20-65

November 16, 2021

Response to Comments
Canada Hill Subdivision – Amended Major Subdivision Plan
Chase Custom Homes & Finance
Windham, ME.

PROJECT: PHASE 2-CANADA HILL SUBDIVISION WINDHAM, MAINE	DATE: 10/20/2021
SHEET TITLE: NET RESIDENTIAL ACREAGE & OPEN SPACE PLAN	SCALE: 1"=100'
CLIENT: CHASE CUSTOM HOMES & FINANCE CO. 290 BRIDGTON ROAD WESTBROOK, MAINE 04092	DESIGNED:
	JOB NO.: 2065
	FILE: 2065 B INVENTORY 3
	SHEET C-1.1

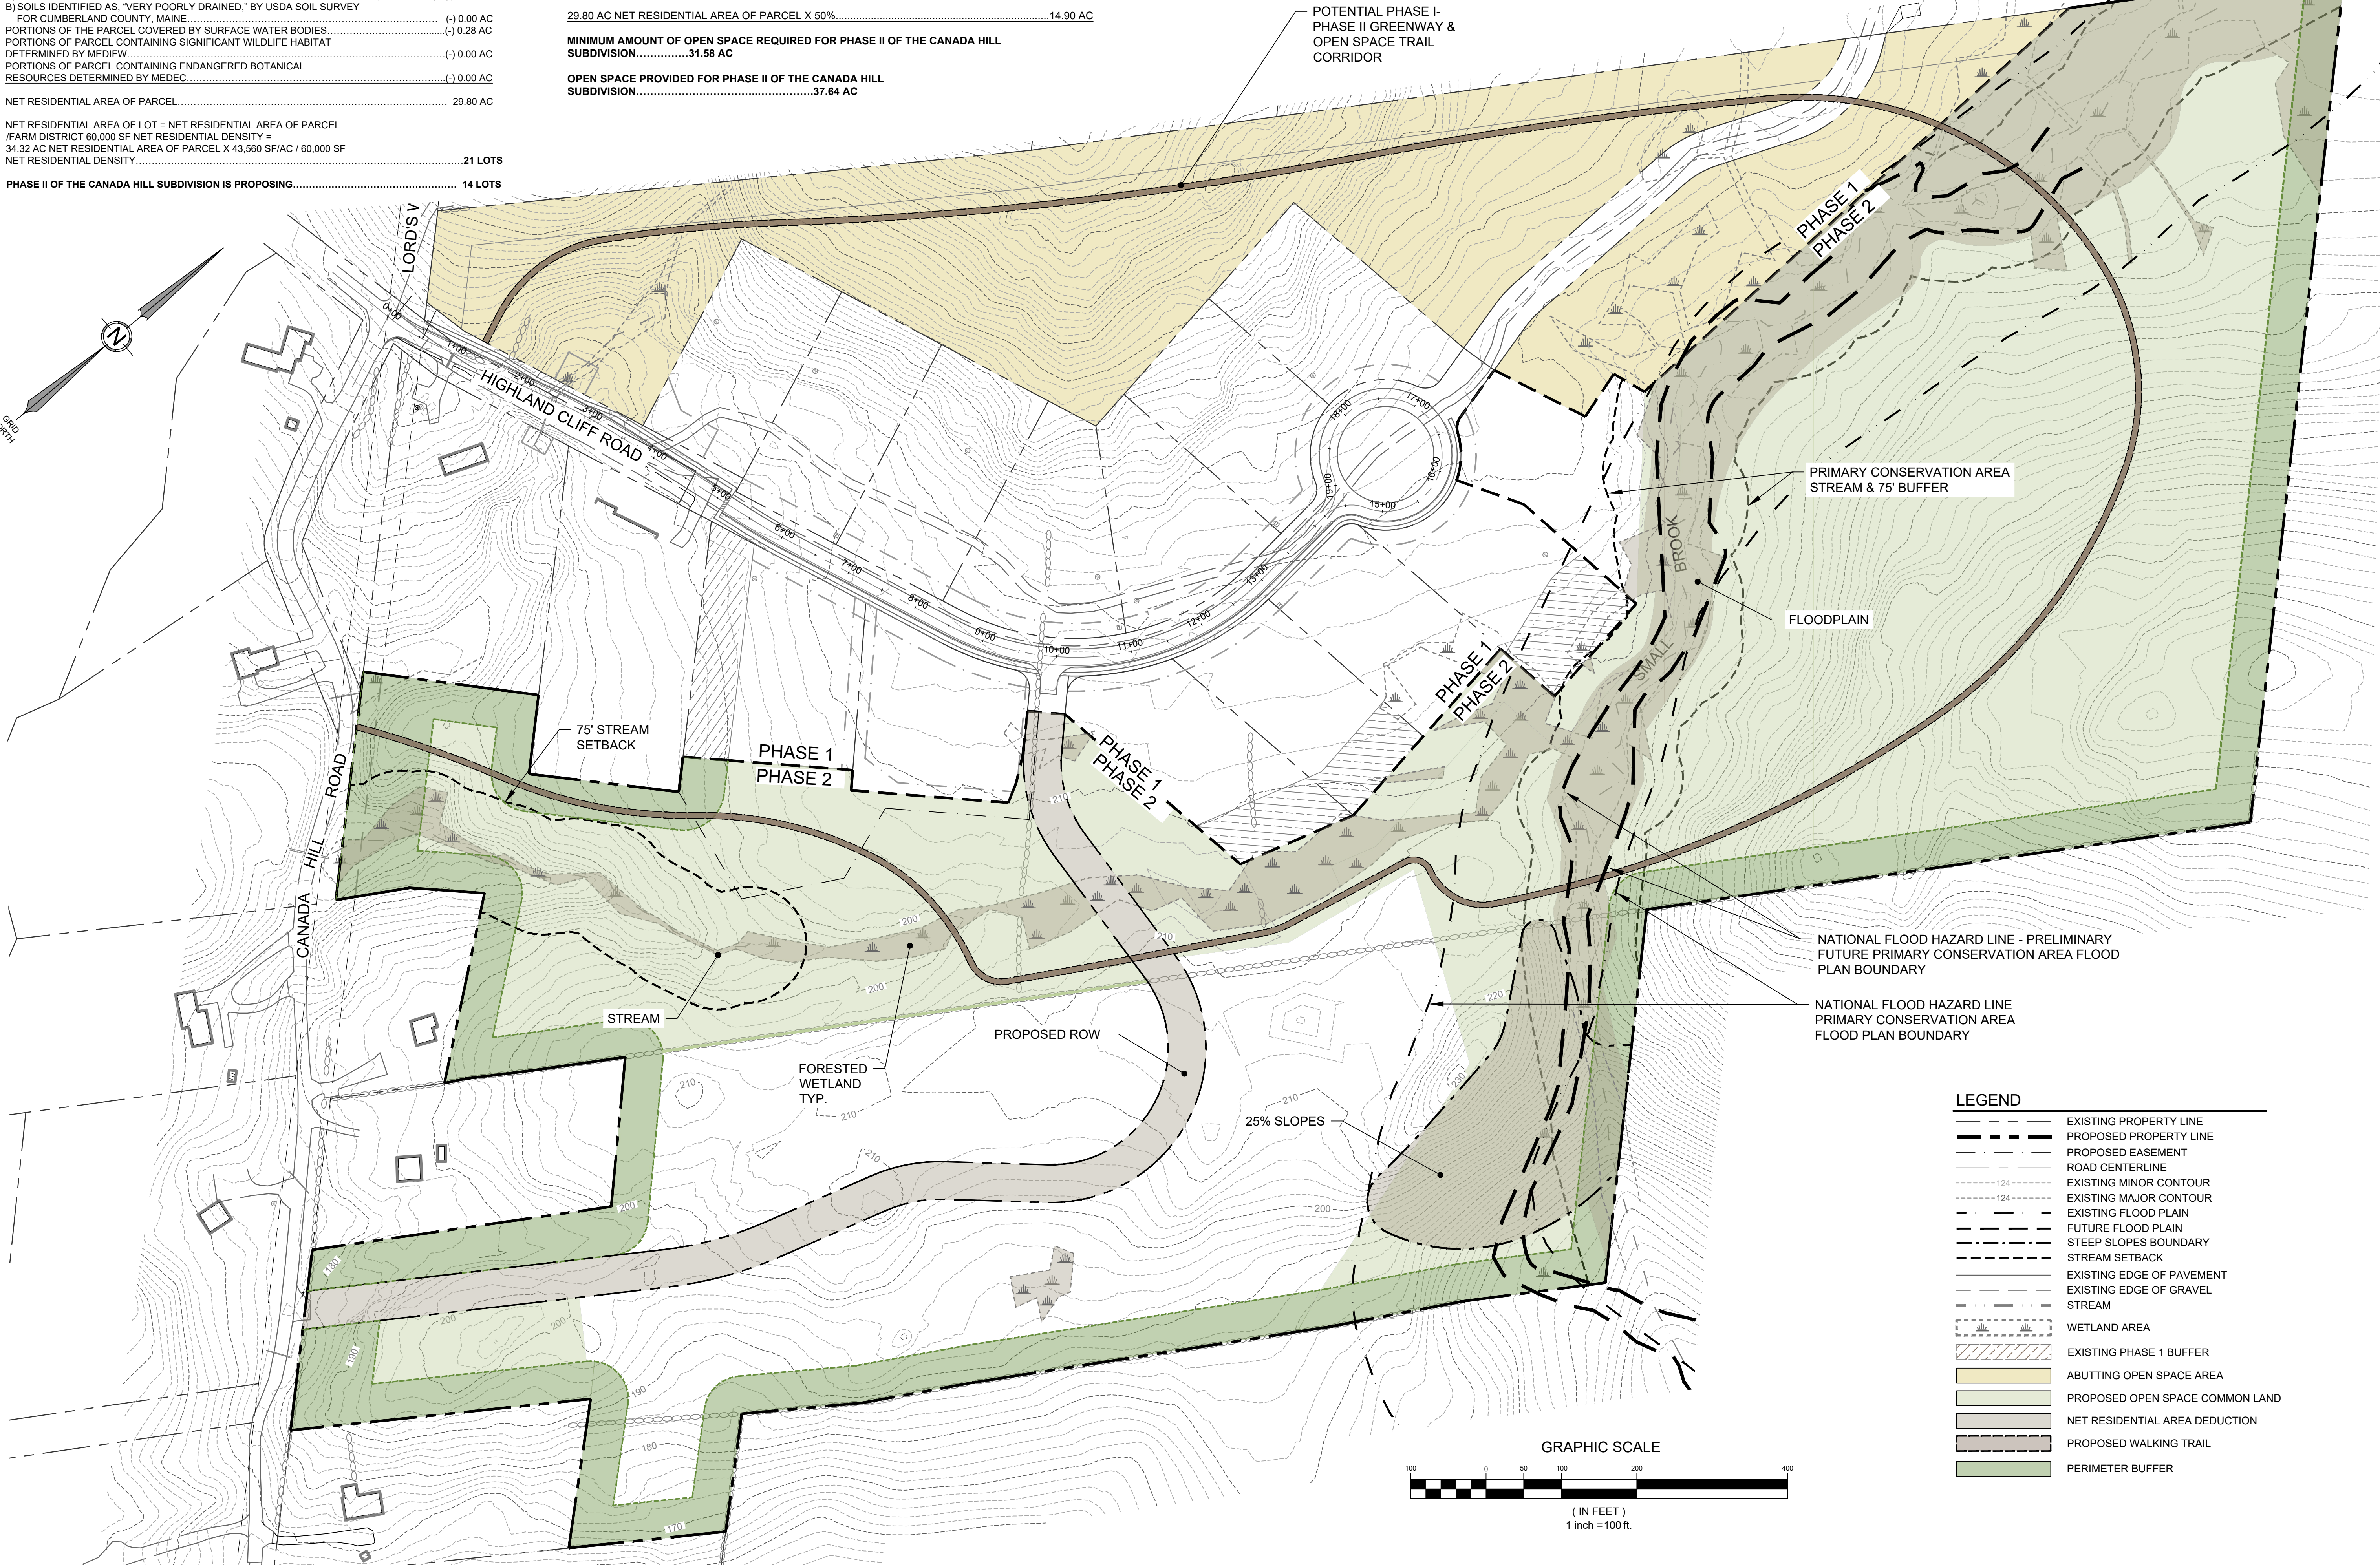
2. Please clarify the number of new subdivision residential lots, per Section 911.K.4.(d)(1), “The subdivider may retain ownership of the remaining land from which the subdivision lots area to be created provided the portion of the remaining land counted toward the subdivision Open Space is subject to permanent ownership of the Open Space to a 3rd party, per Section 911.E.2”.

3. Please explain the Sketch is only showing 12 residential lots when two lots are labelled "Retained by Owner". Are those lots part of the Open Space" calculations and are they proposed to be conveyed to a third and not developed?

Response: *Lot 9-14 consists of an approximately 51.0-acre parcel shown on Town of Windham Tax Map 4. The previously submitted Site Layout Concept Plan has been amended such that the approximately 51.0-acre parcel is proposed to consist of fourteen (14) single family residential lots greater than 30,000 SF to be offered for sale to the general public and open space common land consisting of approximately 37.64 acres for the Canada Hill Amended Major Subdivision Plan*

Per Section 911.E.2, the proposed approximately 37.64 acres of open space will be common property to be owned by the owners of the lots included within the Canada Hill Amended Major Subdivision by means of a lot owners' association.

Response: *As previously started, the Site Layout Concept Plan has been amended to include fourteen (14) single family residential lots to be offered for sale to the general public and approximately 37.64 acres of open space common land to be owned by the owners of the lots included within the Canada Hill Amended Major Subdivision by means of a lot owners' association.*

REVISED PER PLANNING BOARD COMMENTS	APP'D BY
1	11/15/2021
NO.	DATE
